SECTION 4.55 MODIFICATION OF DEVELOPMENT CONSENT

- ADDRESS:** LOT 3 ZOUCHE ROAD, EDMONDSON PARK NSW 2174, LOT 2 ZOUCHE ROAD, EDMONDSON PARK NSW 2174, LOT 5 CAMPBELLTOWN ROAD, EDMONDSON PARK NSW 2174
LOT 3 DP 1272931, LOT 2 DP 1272931, LOT 5 DP 1272931
- DESCRIPTION:** Modification to Development Consent DA-83/2023 under Section 4.55(2) of the Environmental Planning and Assessment Act 1979, to reconfigure the approved subdivision layout to:
- Increase the minimum lot width from 8m to 9m,
 - Removing 11 lots across the precinct
 - Remove all battle axe lots
 - Introduce a rear access laneway connecting Sarbi Circuit to service lots fronting Pedro Crescent and Caesar Boulevard;
 - Amend landscaping design including street trees across the subdivision,
 - Amend building envelope plans where required, and
 - Amend lot numbering across the site.

Reference is made to Modification Application DA-83/2023/A which seeks amendment to Development Consent DA-83/2023 issued for the *Proposed subdivision of Lots 2, 3 and 5 DP1272931 into one-hundred and fifty-eight (158) residential lots, eight (8) super lots for future medium density subdivision, two (2) lots for open space, two (2) drainage lo

Site Plan from Endeavour Energy's G/Net Master Facility Model

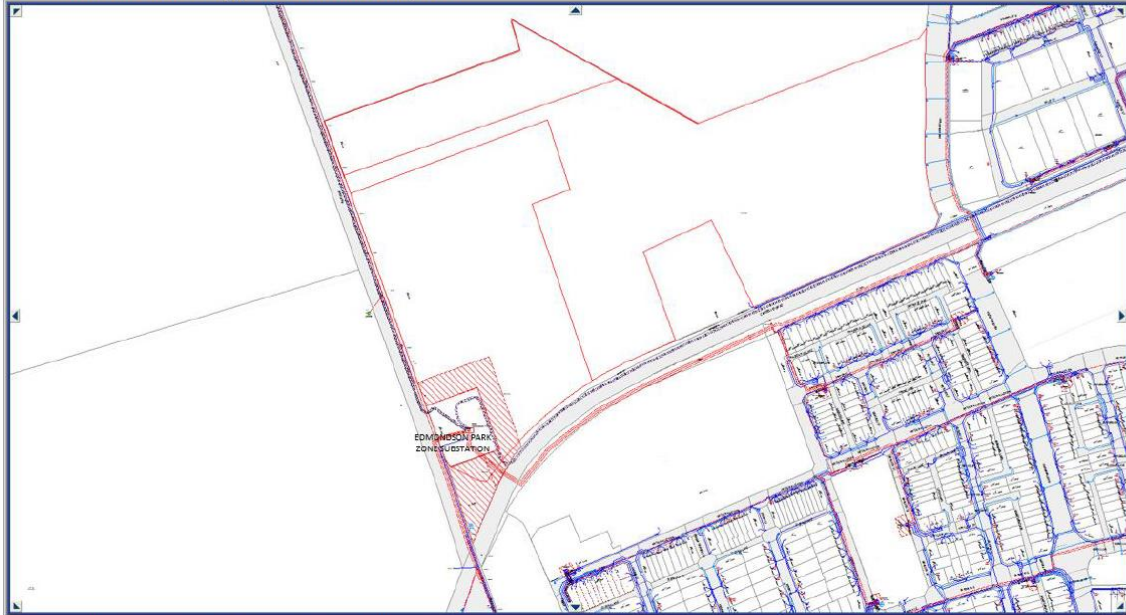
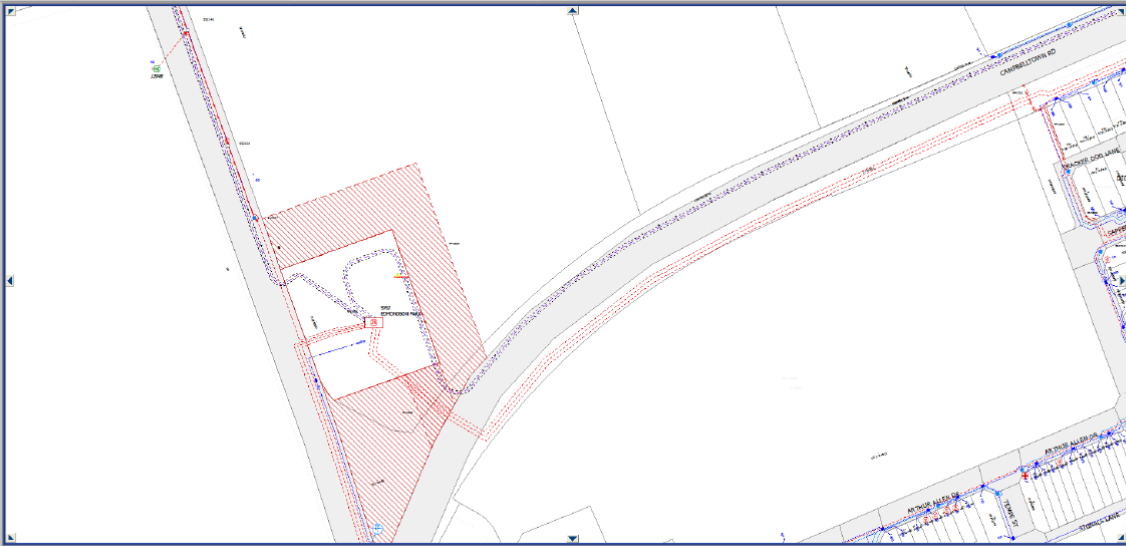
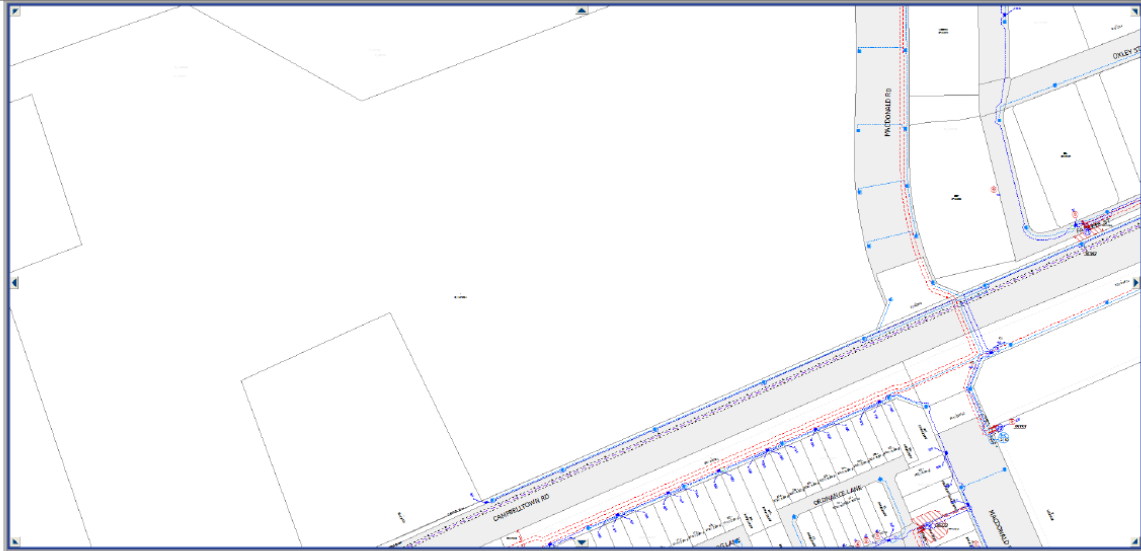
- Low voltage and 11,000 volt / 11 kilovolt (kV) (constructed at 22,000 volt / 22 kV) high voltage overhead power lines, 11 kV high voltage and 33,000 volt / 33 kV high voltage underground cables, underground earth cables and underground pilot cables (carrying protection signals or communications between substations) to the Zouch Road road verge / roadway.

- Low voltage, 11 kV high voltage and 33 kV high voltage underground cables, underground earth cables and underground pilot cables to the Campbelltown Road road verge / roadway.

- Low voltage underground cables (including streetlight columns) to the MacDonald Road road verge / roadway.
- Adjoins Endeavour Energy's Edmondson Park Zone Substation at Zouch Road Ingleburn (Lot 11 DP 1198965) and for which there are associated easements benefitting Endeavour Energy (indicated by red hatching) for:

- 11 kV high voltage and 33 kV high voltage underground cables, underground earth cables and underground pilot cables.
 - Asset protection zone (APZ) for bush fire. The transfer including easement includes the following.

From the plans available in the NSW Planning Portal it does not appear that any provision has been for padmount substations on the site.

- The required padmount substation/s will need to be located within the property (in a suitable and accessible location) and be protected (including any associated cabling) by an easement and associated restrictions benefiting and gifted to Endeavour Energy.

Site Plan from Endeavour Energy's HxGN NetWorks Core NetViewer Master Facility Model. **WARNING: Electricity infrastructure shown is indicative only.**

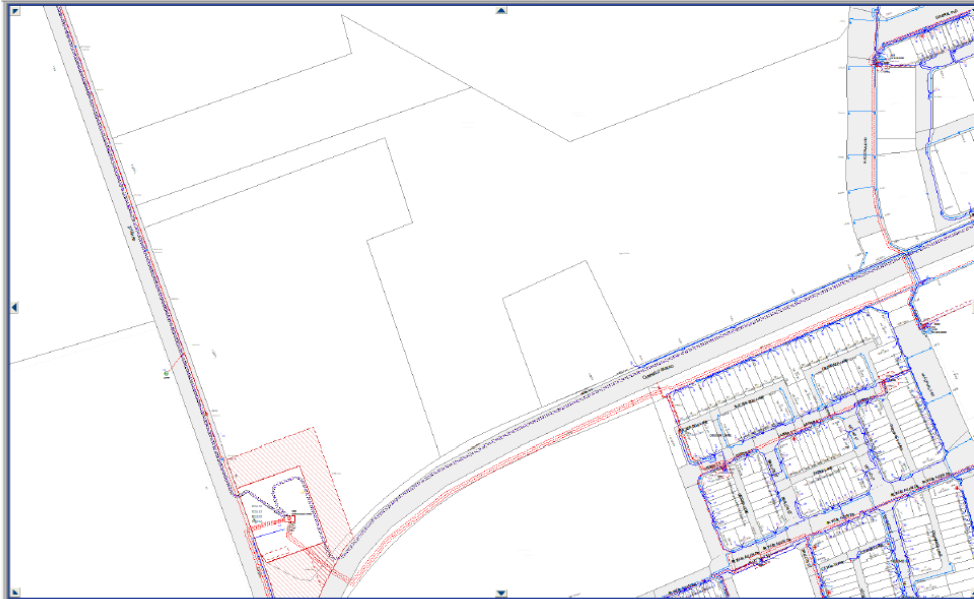
The below extracts of the Plan of Subdivision shows the provision of 3 padmount substations on proposed Lots 29, 66 and 109. Any required padmount substation/s will need to be located within the property (in a suitable and accessible location) and be protected (including any associated cabling not located within a public road / reserve) with an appropriate form of property tenure as detailed in the attached copy of Endeavour Energy's 'Land Interest Guidelines for Network Connection'.
